City of Avondale Estates
Planning Architectural Zoning Board
Staff Review, Variances *

November 17, 2025, PAZB Meeting

Applicant: 278 Oak Holdings LLC: Jetha Wagner, Avila Development

Property Address: 136 Laredo Drive, 2968 Parry Street, 147 Oak Street, 2950 Franklin Street, and 2556 Franklin Street (Oak Parcel)

D)

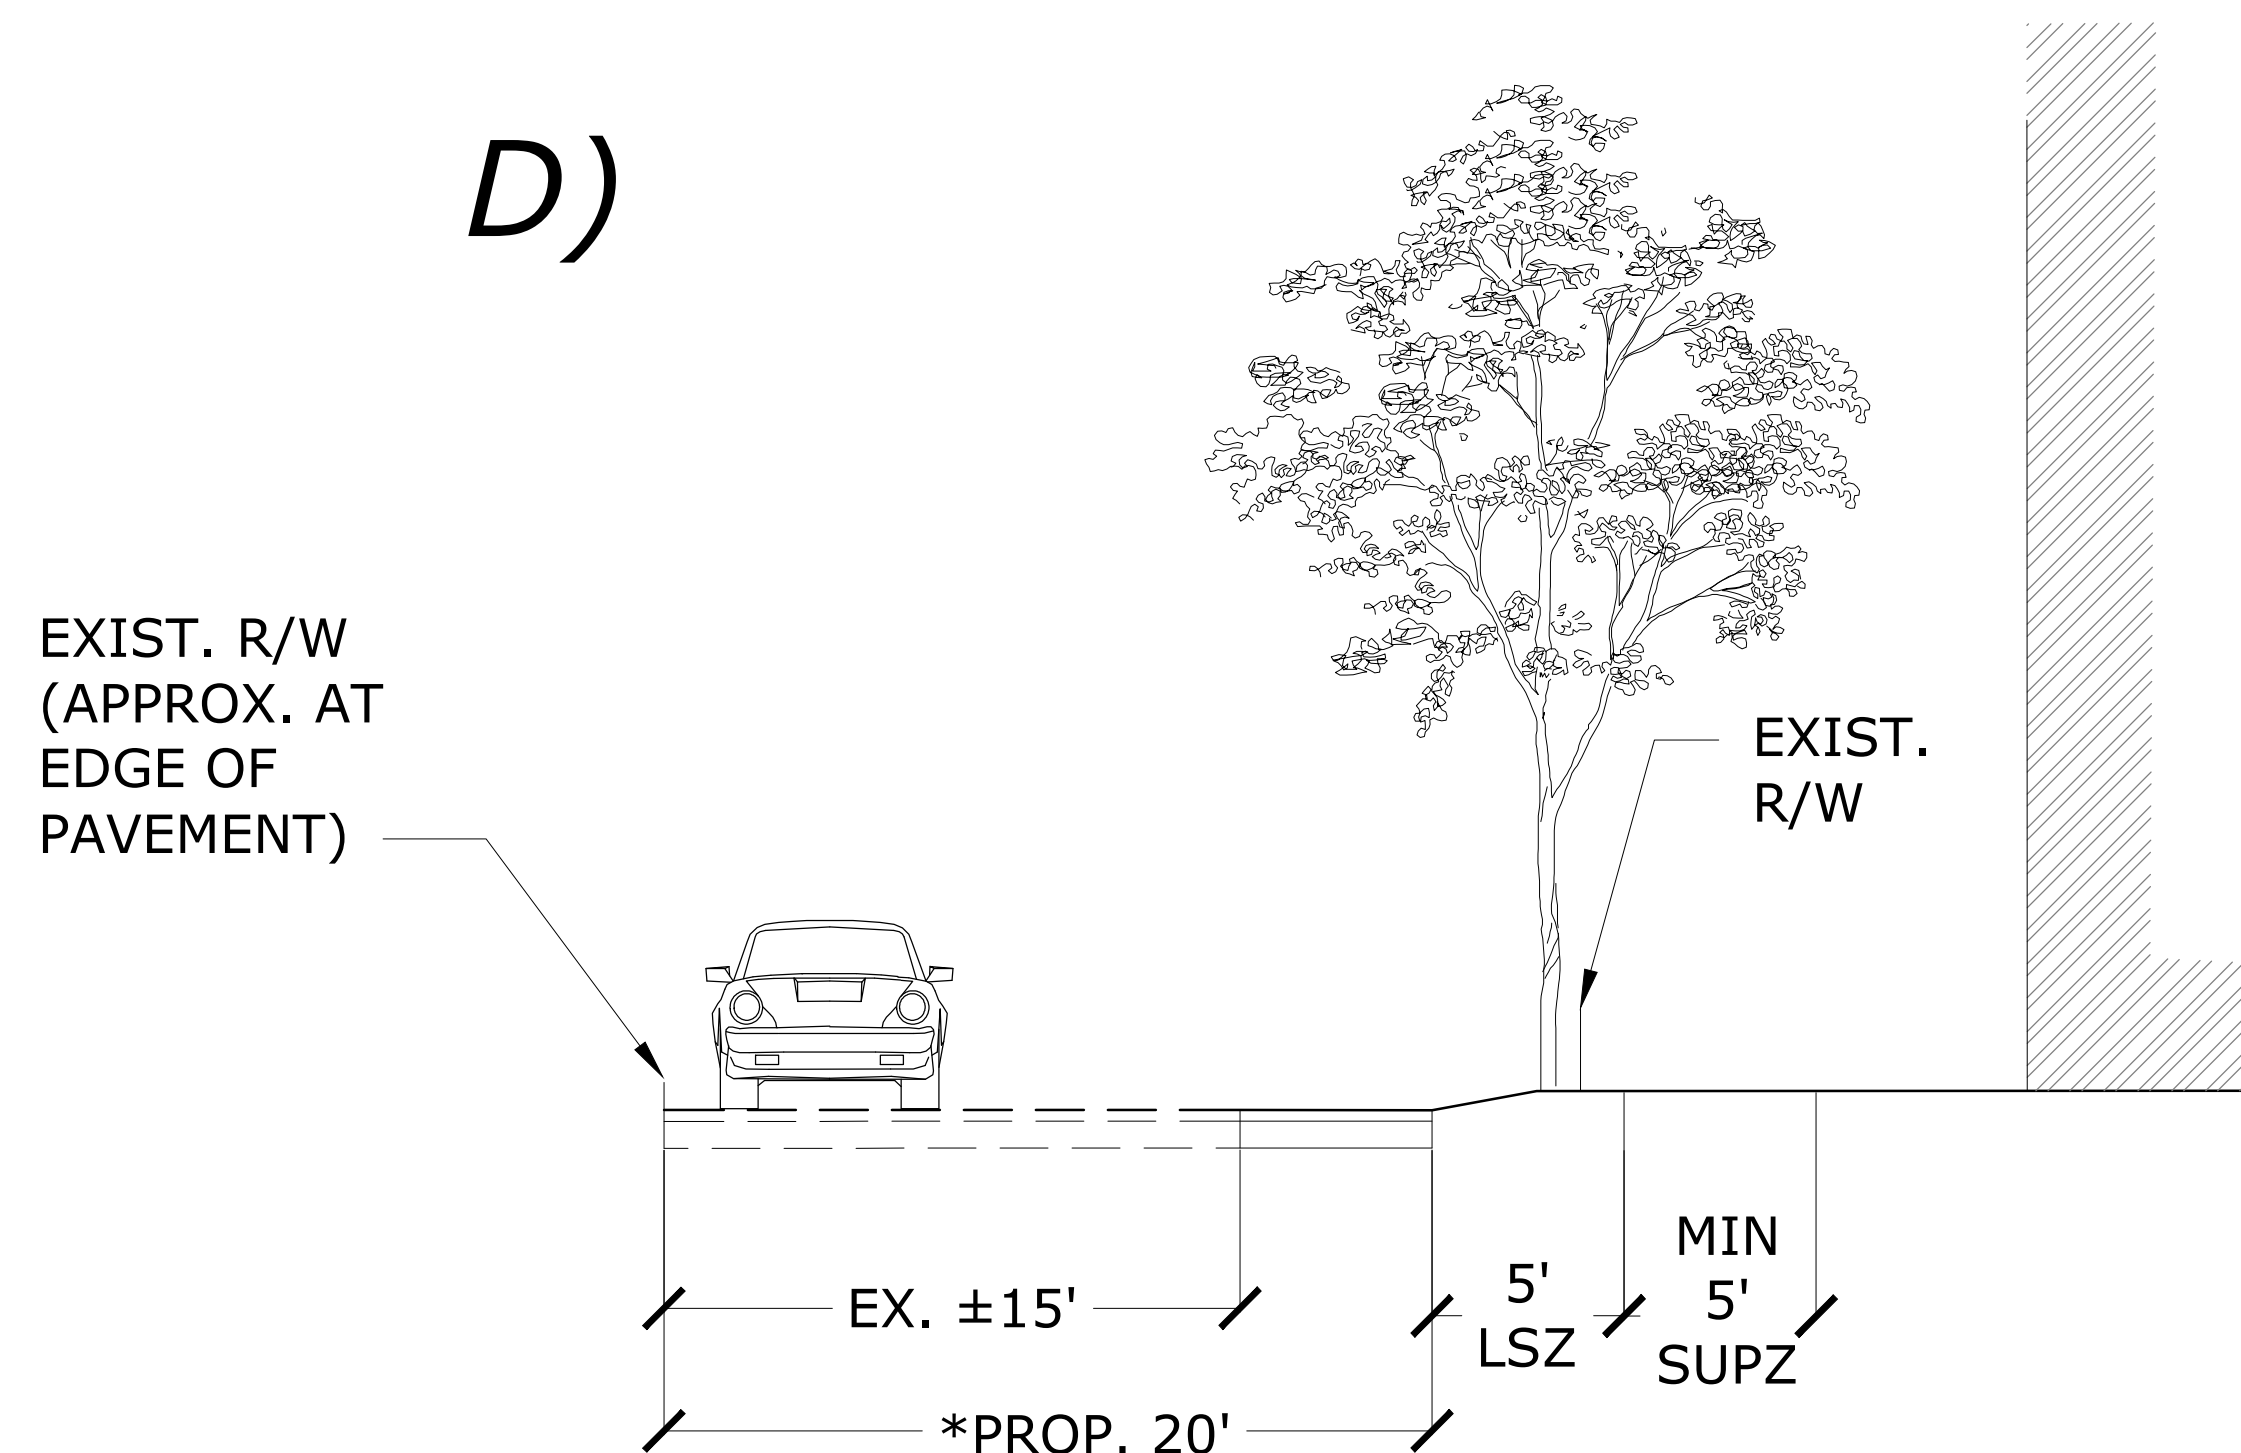
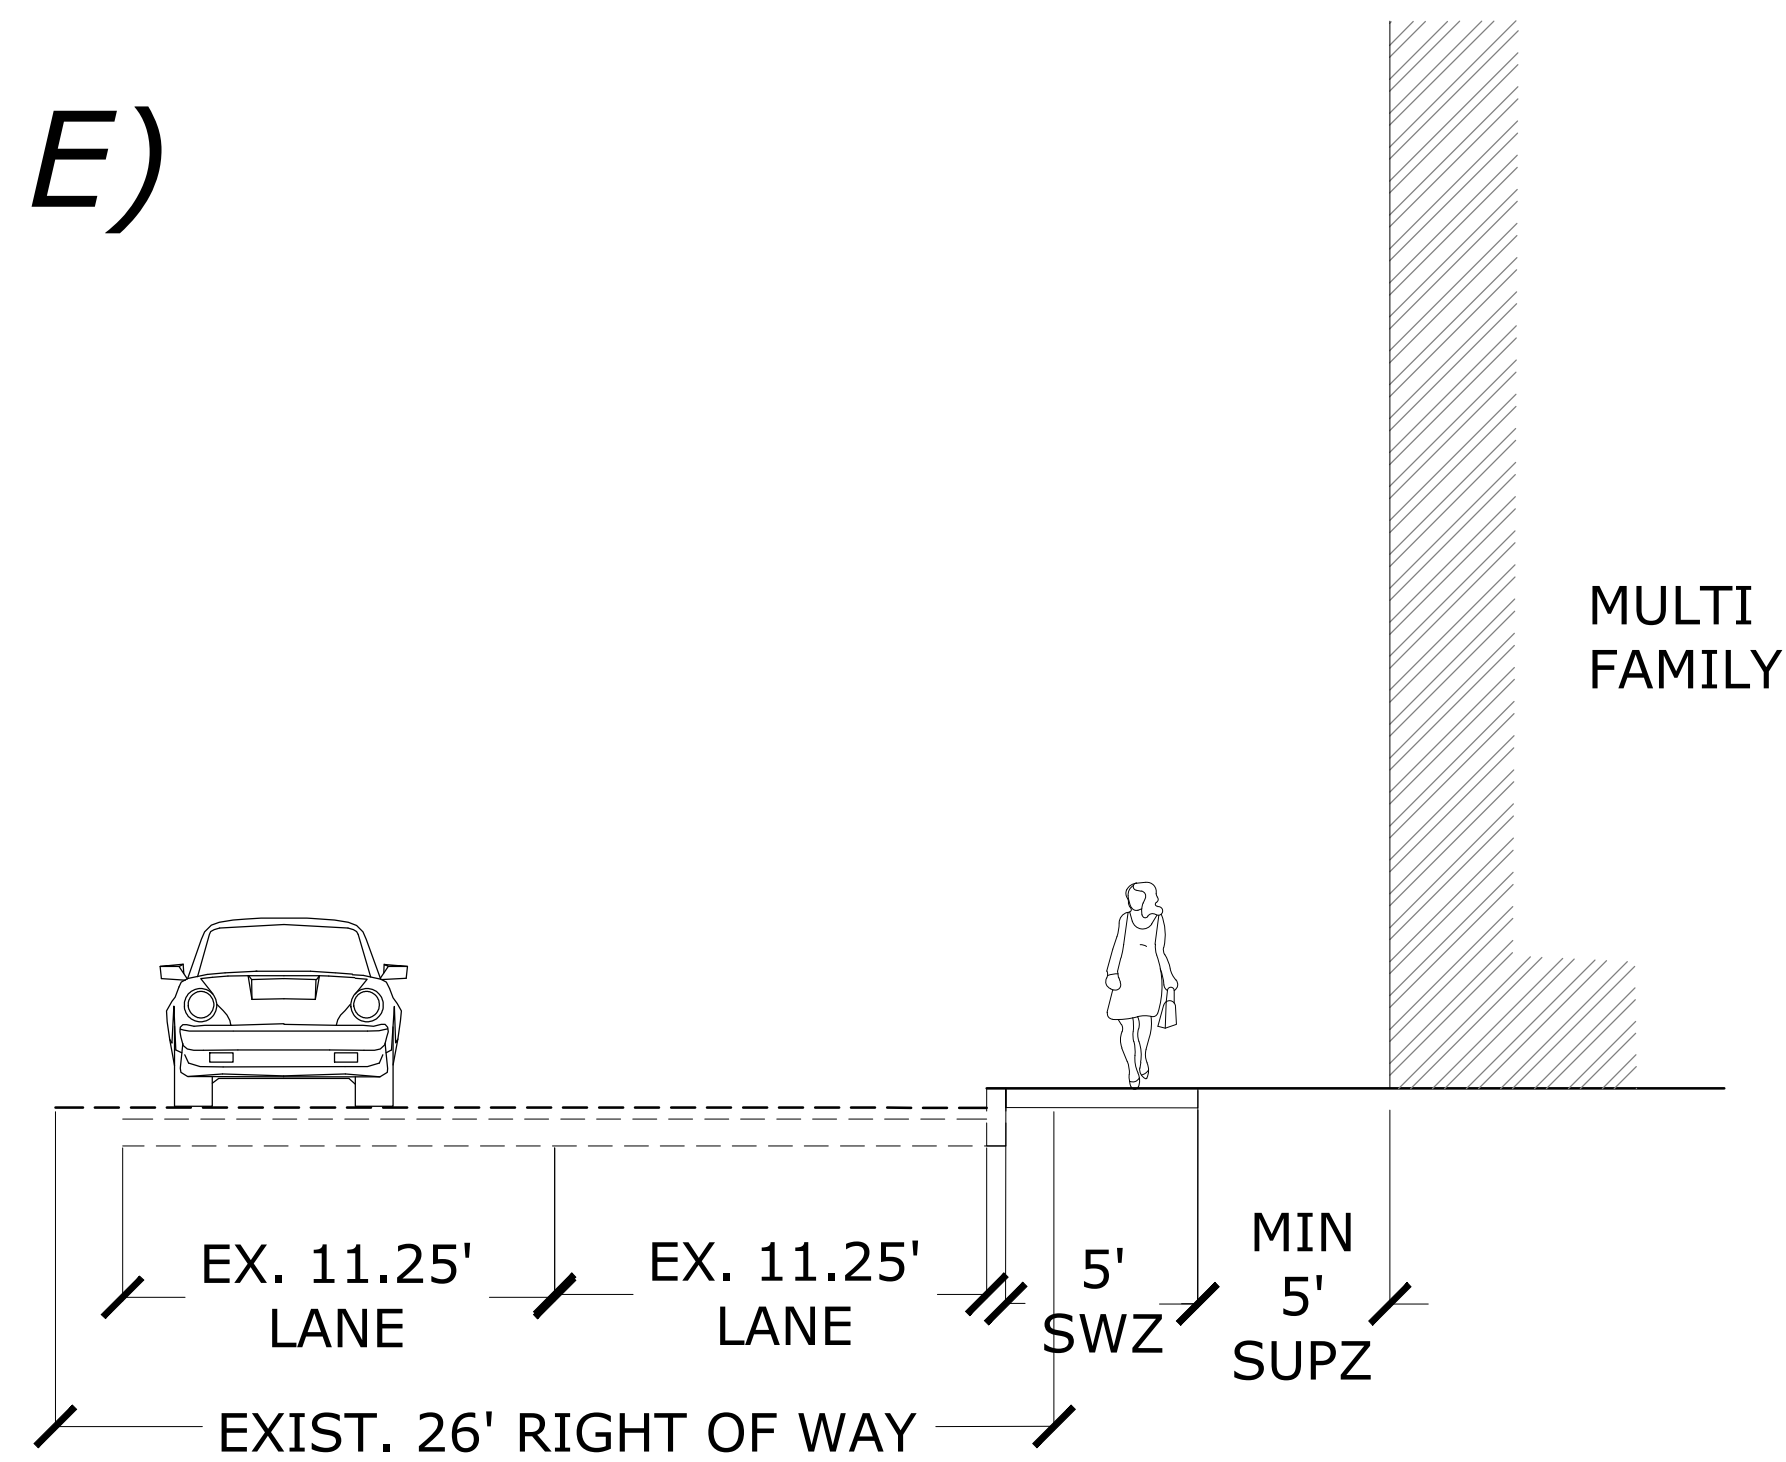
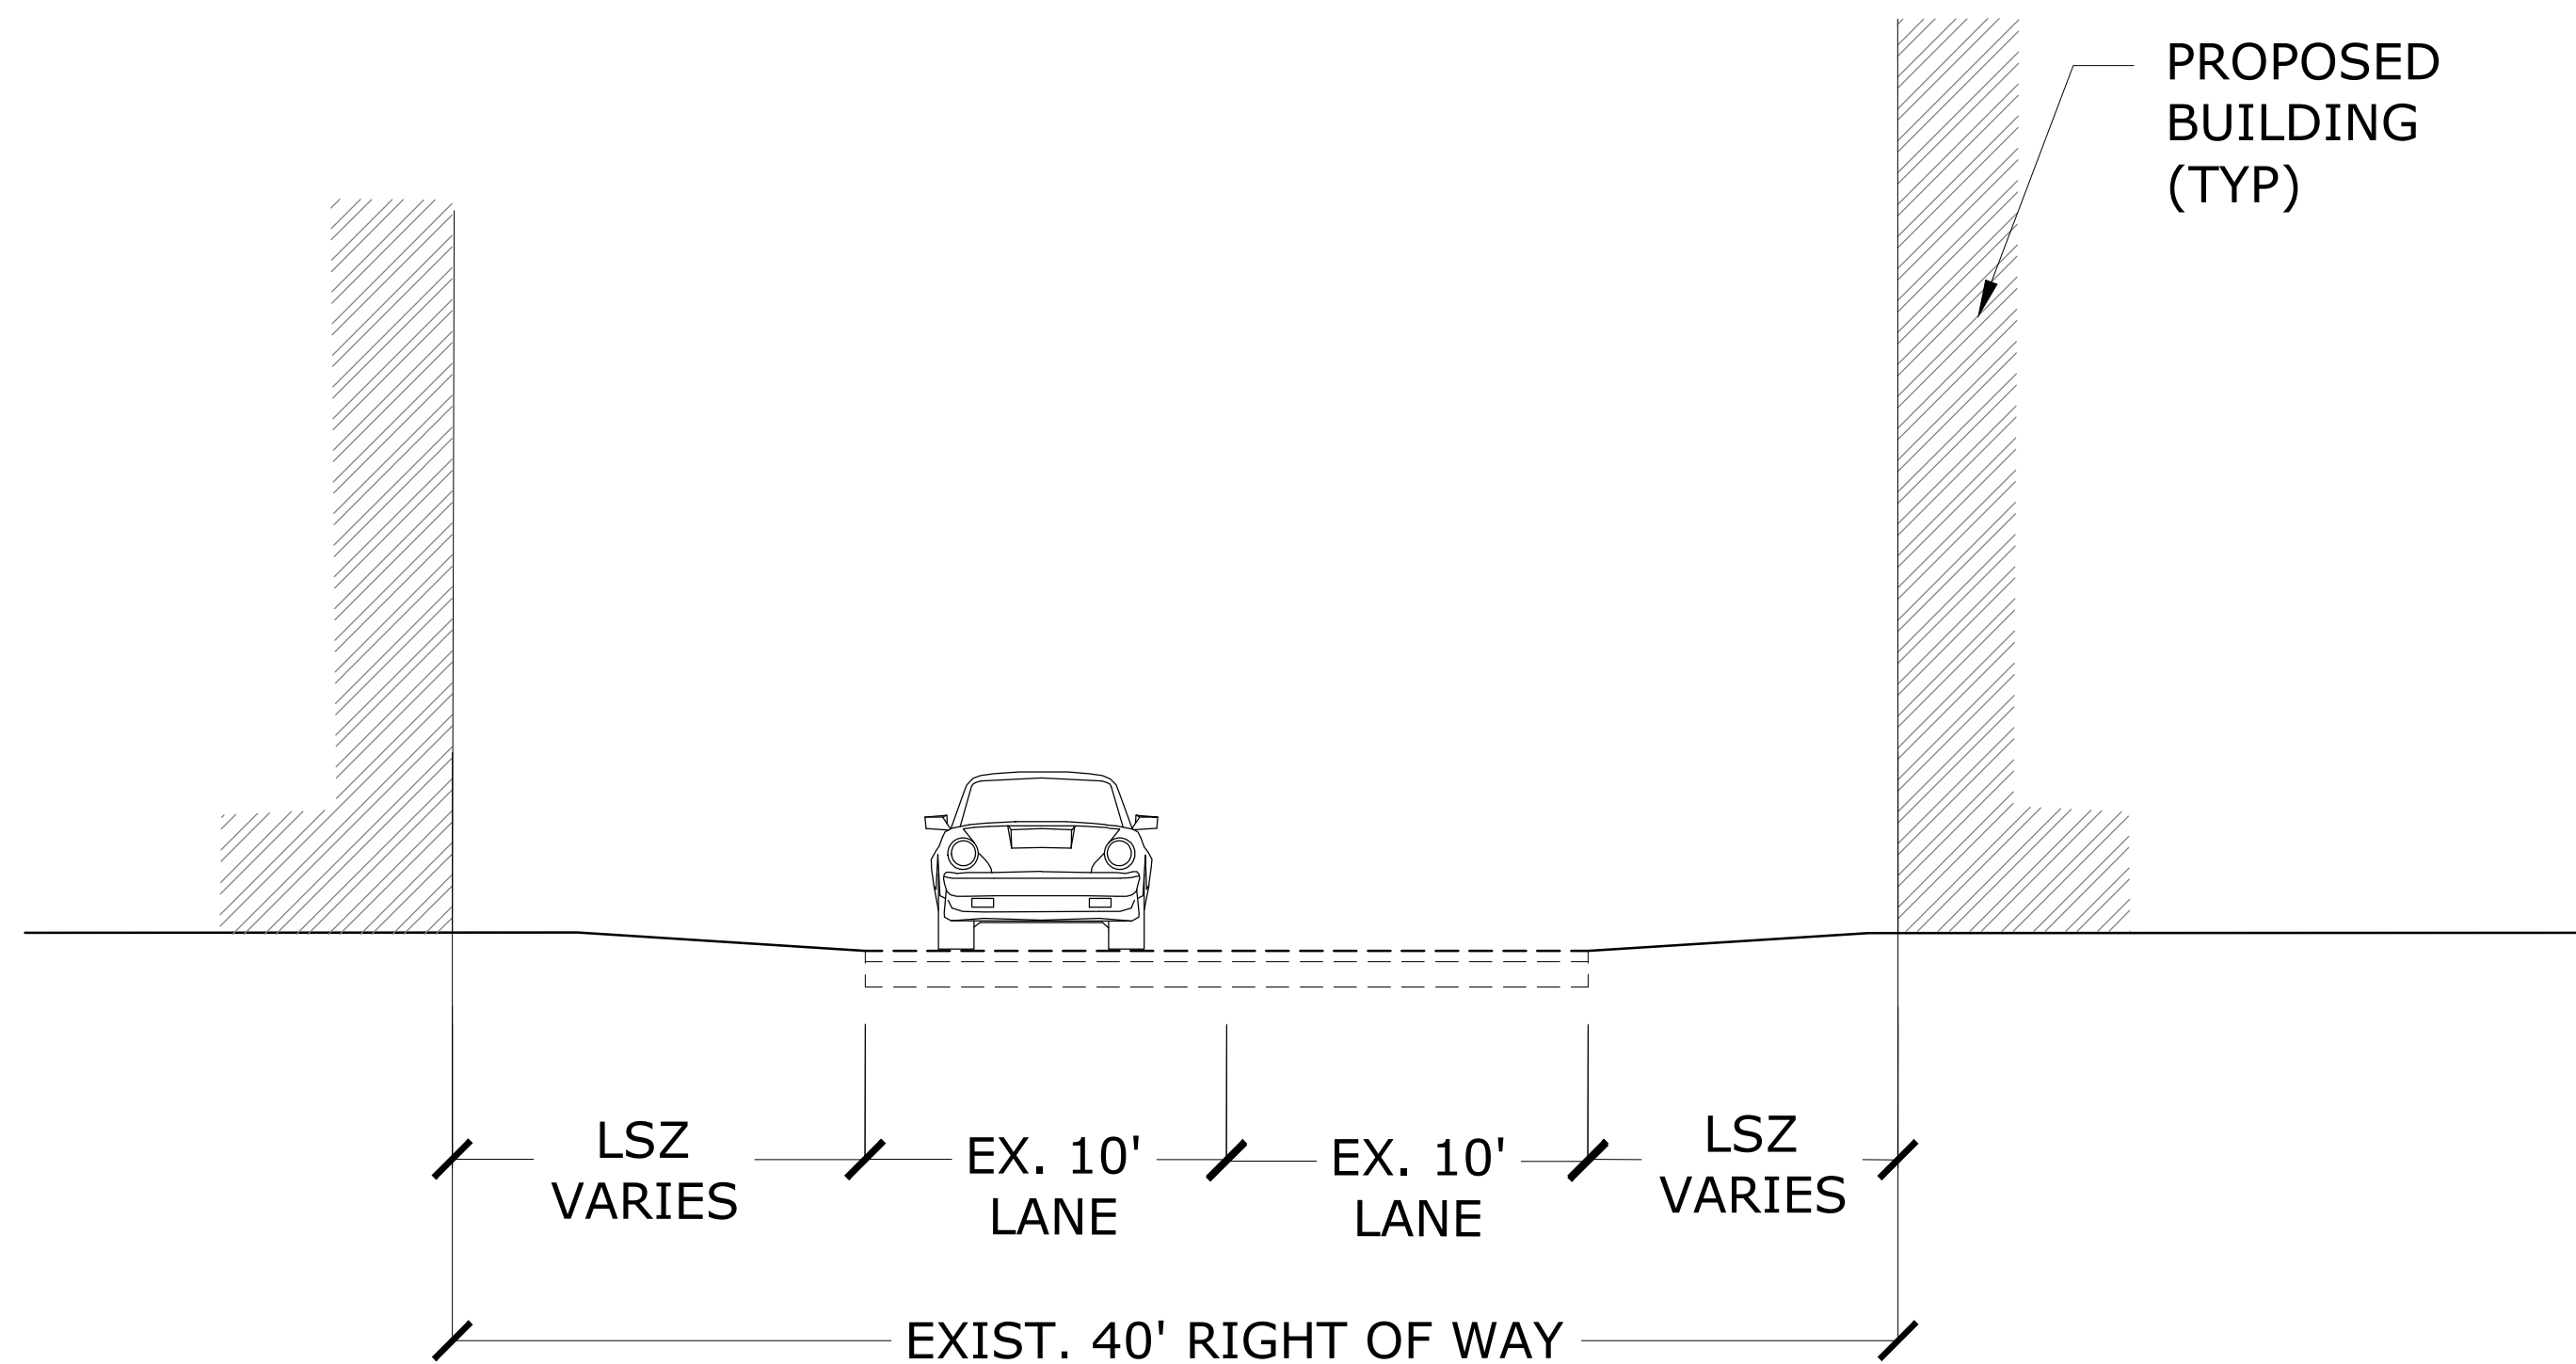
FROM: Figure 21-3.2.8.B.4.d and Table 3.2.8.E reduce type D street section from 40' ROW and 5' SUPZ to building face.

FROM: Figure 21-3.2.8.B.4.c and Table 3.2.8.E reduce type C3 street section from 40' ROW, 2' additional LSZ and 5' SUPZ to building face.

FROM: Figure 21-3.2.8.B.4.c and Table 3.2.8.E realign type C3 street section from 40' ROW, 2' additional LSZ and 5' SUPZ to building face.

FROM: Figure 21-3.2.8.B.4.d and Table 3.2.8.E reduce type D street section from 40' ROW and 5' SUPZ to building face.

FROM: Figure 21-3.2.8.B.4.c and Table 3.2.8.E reduce type C2 street section from 40' ROW, 5' SWZ, and 5' SUPZ to building face.
